# Wollongong Local Planning Panel Assessment Report | 1 September 2020

<b>WLPP No.</b>	Item 4
<b>DA No.</b>	DA-2019/1356
<b>Proposal</b>	Residential - Eight storey residential flat building comprising 14 residential units over two levels of basement carparking.
<b>Property</b>	9-11 Park Street, Wollongong
<b>Applicant</b>	PRD Architects
<b>Responsible Team</b>	Development Assessment and Certification - City Centre Team (MJ)

## ASSESSMENT REPORT AND RECOMMENDATION

Title:  
25M HEIGHT PLANE

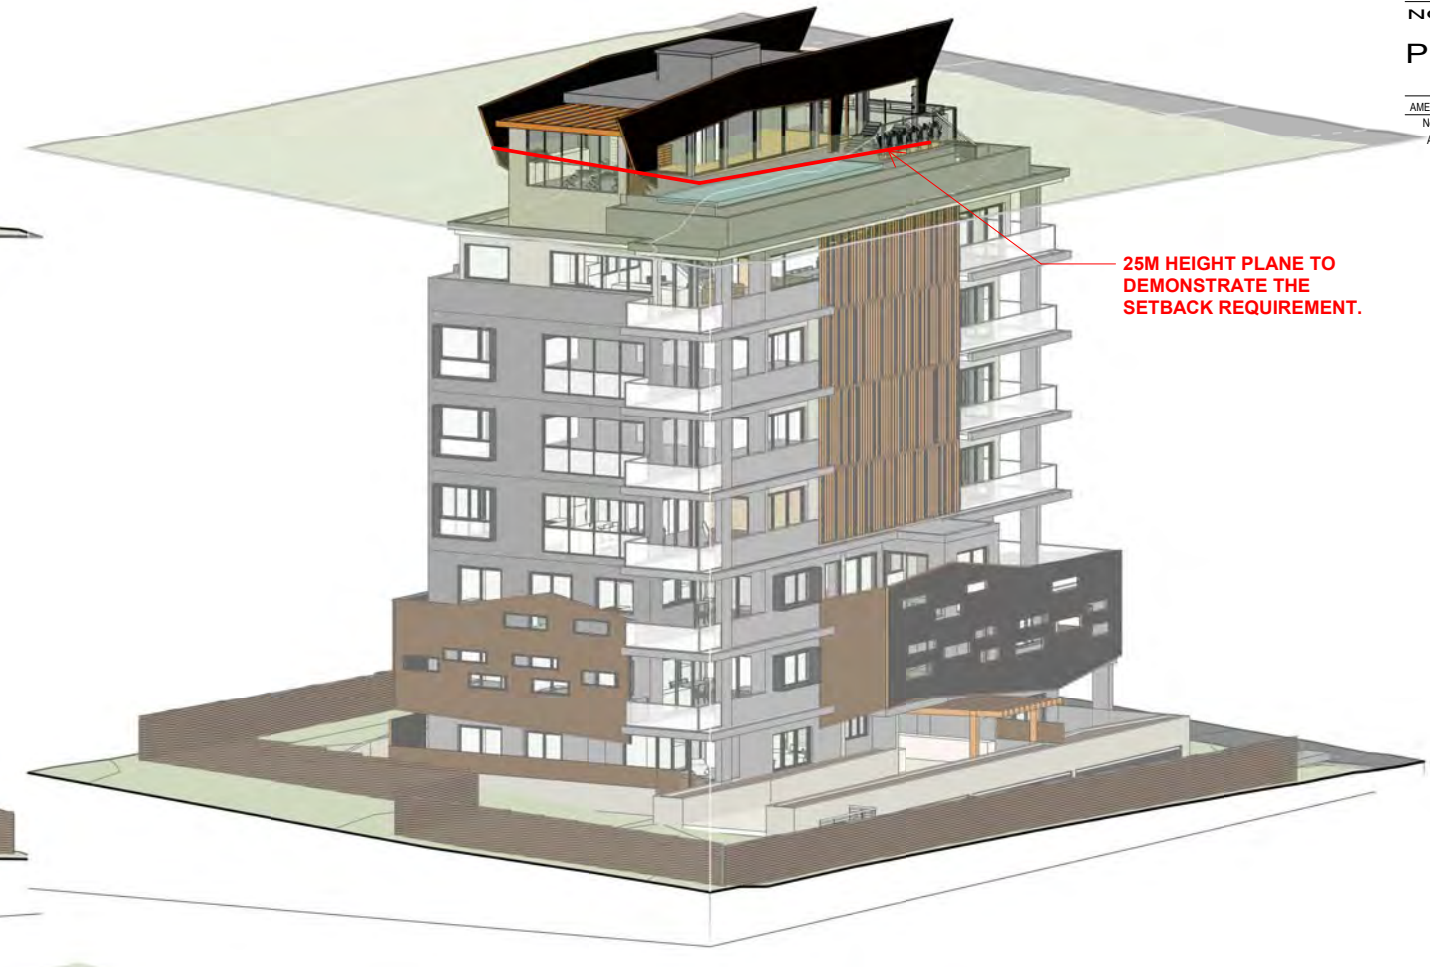
<i>Standards/controls</i>	<i>Comment</i>	<i>Compliance</i>
	<p>East/Rear: 9 – 13.3m</p> <p><b><u>Over 25M (LEVEL 8 - PARTIAL)</u></b></p> <p>It is noted part of the level 8 structure (wall, ceiling, batten screening) extends beyond 25m in height, these areas are setback as follows:</p> <p>North: 12.57m</p> <p>South: 9m</p> <p>East/Rear: 12m</p> <p>These areas comply with setback requirements for habitable and non-habitable areas.</p> <p>As this level is not a 9<sup>th</sup> storey and the subject areas over 25m in height comprise only part of the level, these setback requirements should not be extended to the full extent of level 8.</p>	Y
<p><b><u>Objective 3J-3</u></b></p> <p><i>Car park design and access is safe and secure</i></p> <p><b><u>Design Guidance</u></b></p> <ul style="list-style-type: none"> <li>- Supporting facilities within car parks (garbage rooms, storage areas, car wash bays) can be accessed without crossing parking spaces</li> <li>- A clearly defined and visible lobby or waiting area should be provided to lifts and stairs.</li> <li>- Permeable roller doors allow for natural ventilation and improve the safety of car parking areas by enabling passive surveillance.</li> </ul> <p><b><u>Objective 3J-4</u></b></p> <p><i>Visual and environmental impact of underground car parking are minimised</i></p> <p><b><u>Design Guidance</u></b></p> <ul style="list-style-type: none"> <li>- Excavation should be minimised through efficient carpark layouts and ramp design.</li> <li>- Protrusion of car parks should not exceed 1.0m above ground level.</li> </ul>	<p>Supporting facilities adequately located.</p> <p>Lobby is defined.</p> <p>Roller Shutter doors proposed within the basement beyond visitor parking.</p> <p>All parking below street level in basement.</p> <p>Ventilation incorporated into the design.</p> <p>The basement podium protrudes ~1.5m on north western edge of building, largely due to slope of site.</p> <p>This is further discussed at the WDCP 2009 section of this report</p>	<p>Y</p> <p>N</p>

SHADOW DIAGRAMS- SUMMER SOLSTICE

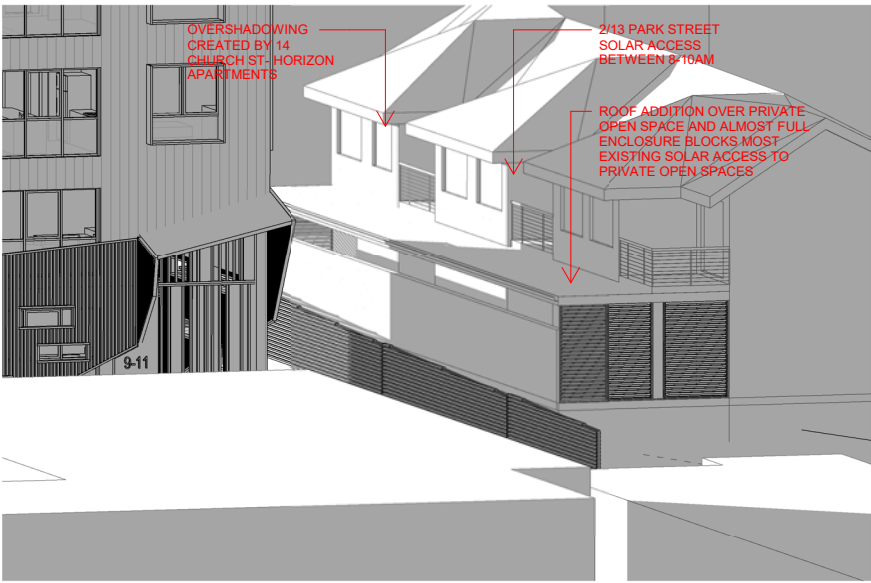
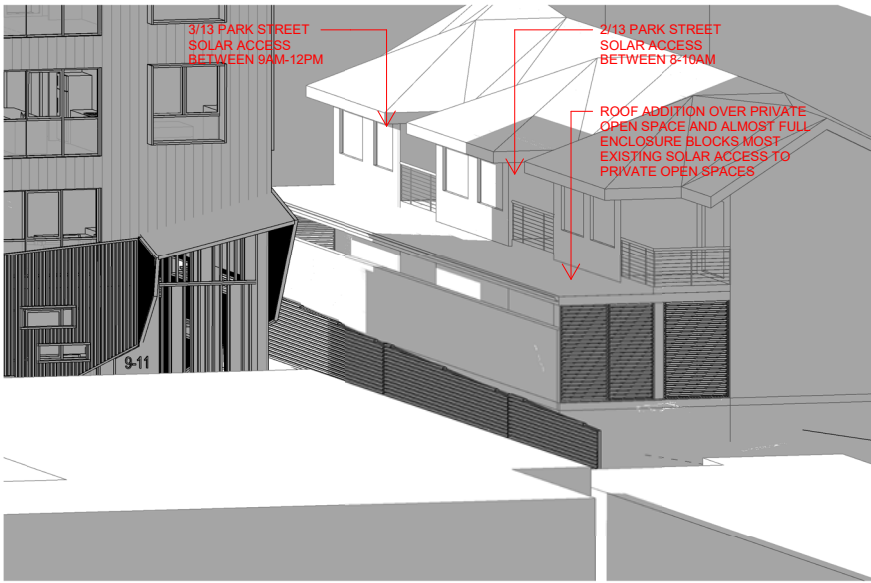
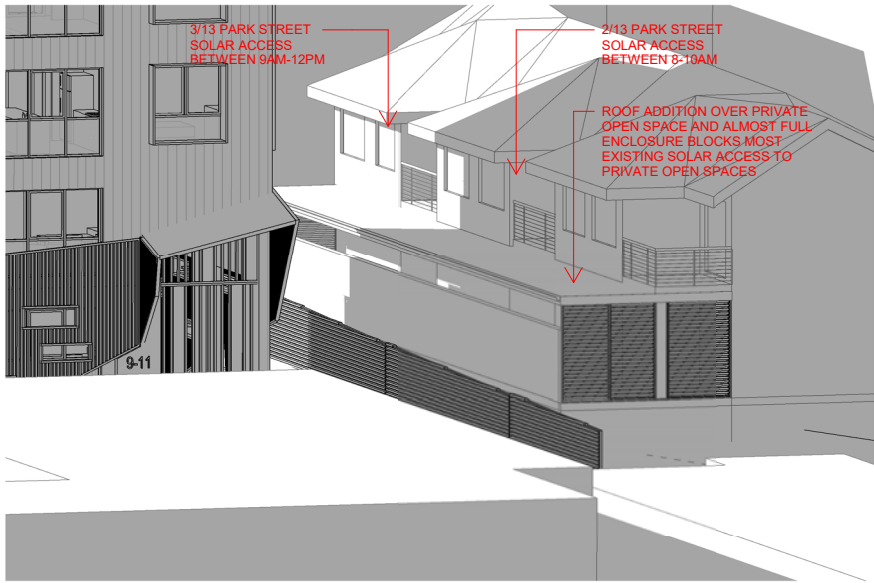
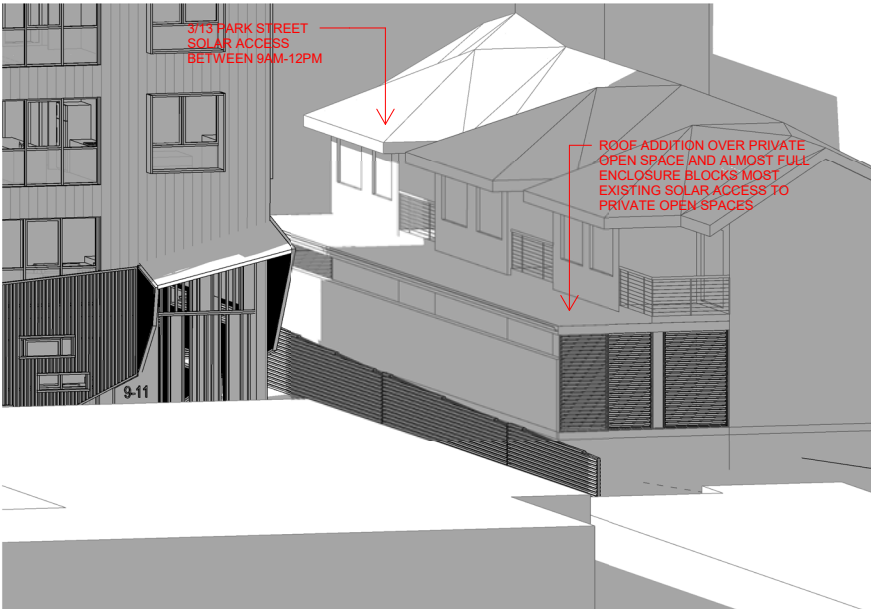
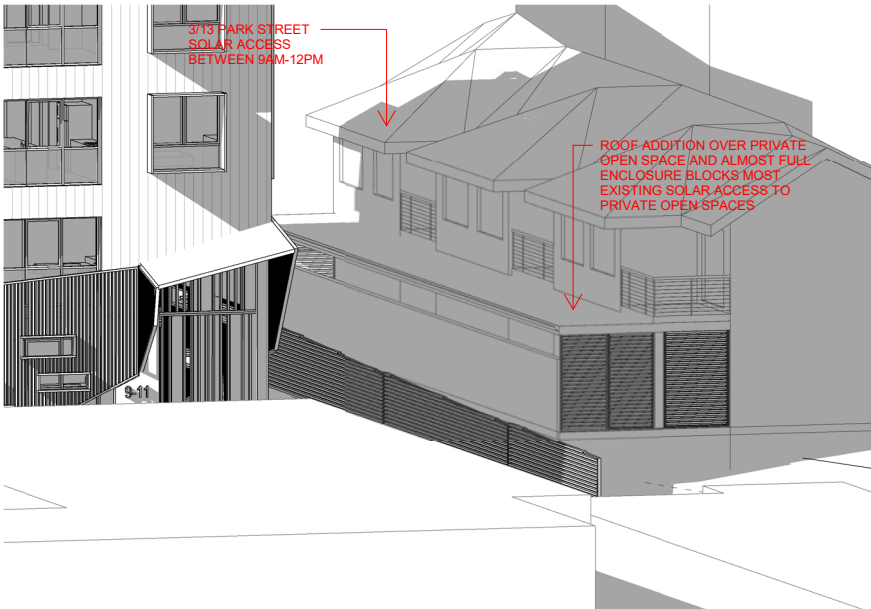
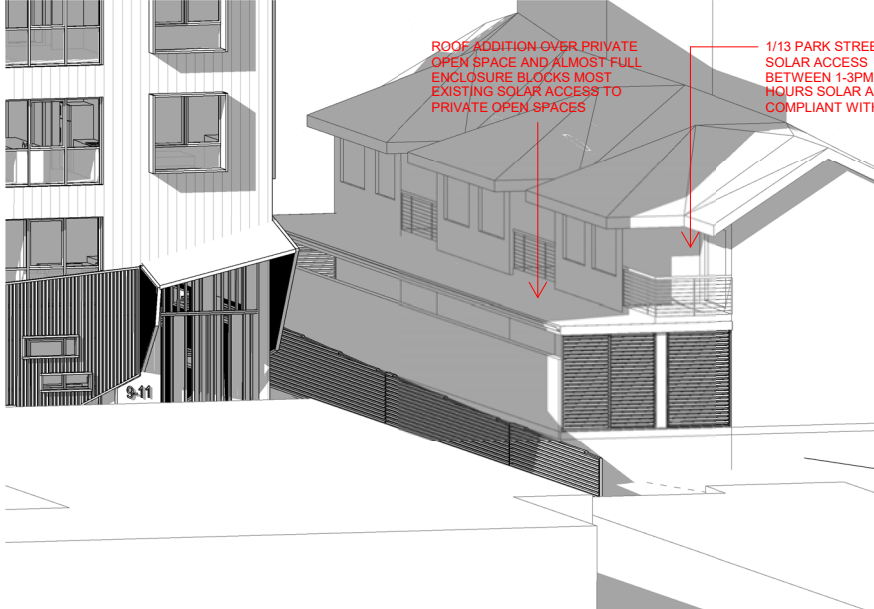
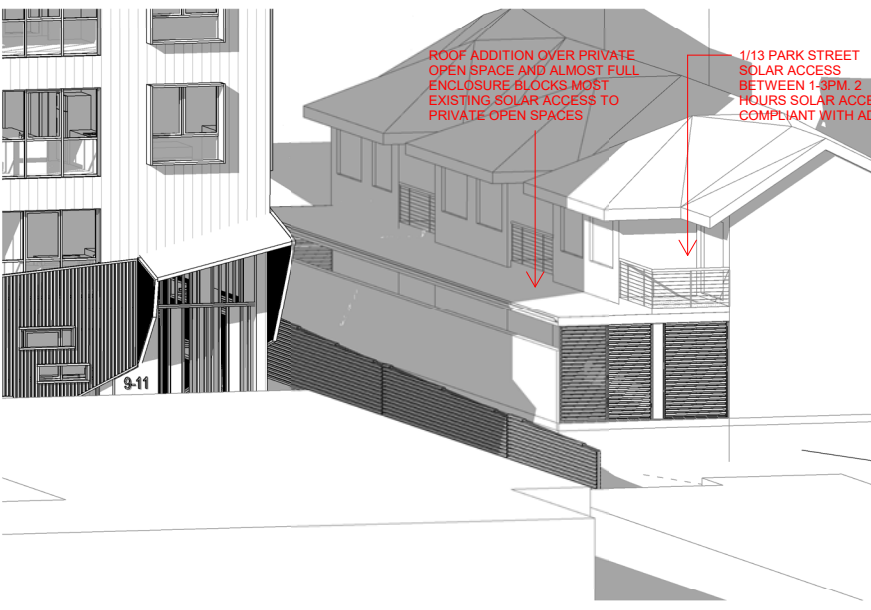
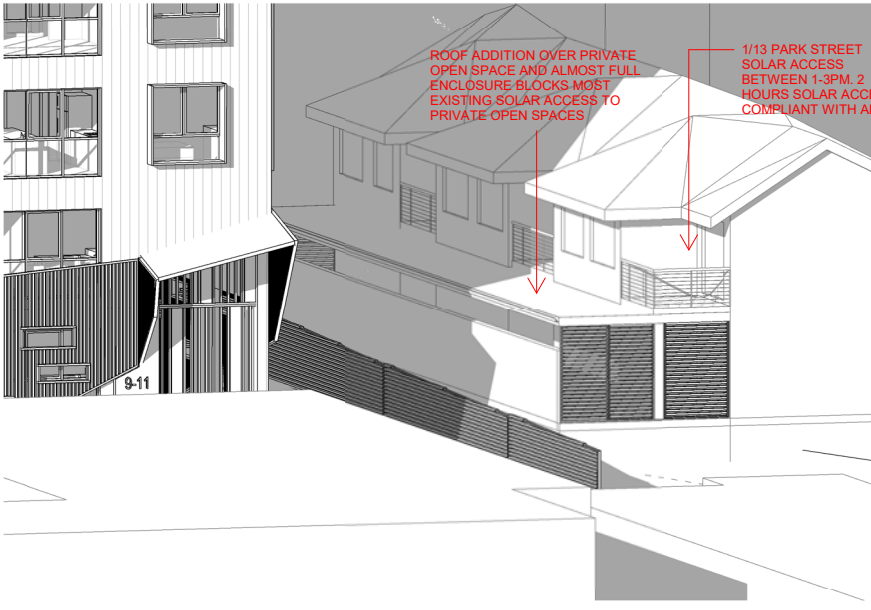
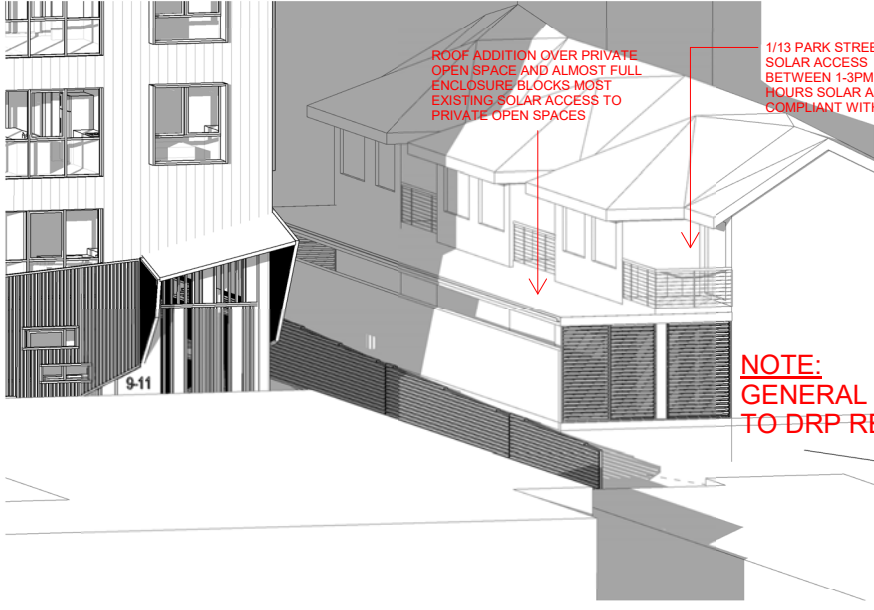
<i>Standards/controls</i>	<i>Comment</i>	<i>Compliance</i>
<b>Part 3 Siting the development</b>		
<p><b><u>3B Orientation</u></b></p> <p>Buildings must be oriented to maximise northern orientation, response to desired character, promote amenity for the occupant and adjoining properties, retain trees and open spaces and respond to contextual constraints such as overshadowing and noise.</p> <p><u>Objective 3B-1:</u></p> <p><i>Building types and layouts respond to the streetscape and site while optimising solar access within the development</i></p> <p><u>Design Guidance</u></p> <ul style="list-style-type: none"> <li>- Buildings should define the street by facing it and providing direct access.</li> </ul> <p><u>Objective 3B-2</u></p> <p><i>Overshadowing of neighbouring properties is minimised during mid- winter</i></p> <p><u>Design Guidance</u></p> <ul style="list-style-type: none"> <li>- Overshadowing should be minimised to the south or down hill by increased upper level setbacks</li> <li>- Refer sections 3D &amp; 4A below for solar access requirements</li> <li>- A minimum of 4 hours of solar access should be retained to solar collectors on neighbouring buildings</li> <li>- 70% of apartments – Living &amp; POS - 2 hours direct sunlight between 9am – 3pm</li> <li>- Where an adjoining property does not currently receive the required hours of solar access, the proposed building ensures solar access to neighbouring</li> </ul>	<p>Building is oriented to take advantage of northern orientation.</p> <p>Street frontage addresses Park Street. Direct Pedestrian Access is provided.</p> <p>OVERSHADOWING OF NEIGHBOURING PROPERTY TO SOUTH (13 Park St):</p> <p>13 Park St contains a four (4) unit townhouse development.</p> <p><u>70% of 4 = 2.8 (3 UNITS)</u></p> <p>3 unit's POS &amp; living areas required to receive 2 hours solar access between 9am – 3pm.</p> <p>Shadow diagrams have been submitted with the application which demonstrate the following:</p> <p><u>Solar Access:</u></p> <p>UNIT 1: Solar access 1pm – 3pm = ~2 hours</p> <p>UNIT 2: 9 – 10am (partial) = less than 1 hour</p> <p>UNIT 3: 9 – 10am = ~1 hour</p> <p>UNIT 4: 9am – 12pm = ~3 hours</p>	<p>Y</p> <p>N</p>

Standards/controls	Comment	Compliance
<p>properties is not reduced by more than 20%</p> <ul style="list-style-type: none"> <li>- If the proposal will significantly reduce the solar access of neighbours, building separation should be increased beyond minimums contained in section 3F Visual privacy</li> </ul>	<p>Less than 50% of dwellings receive the minimum solar access.</p> <p>It was noted by the applicant that the affected townhouse development includes awnings which shade the living and POS areas.</p> <p>The occupants of the townhouses have claimed the awnings have been designed to allow winter solar access into the living and POS areas.</p> <p>If it is assumed the affected dwellings do not currently receive the minimum solar access, the development would still result in an excess of 20% reduction in solar access.</p> <p>The development also entails several building separation encroachments on the southern eastern elevation which exacerbates overshadowing impacts.</p> <p>Considering the context of the related non-compliances, variation to this guidance is not supported.</p>
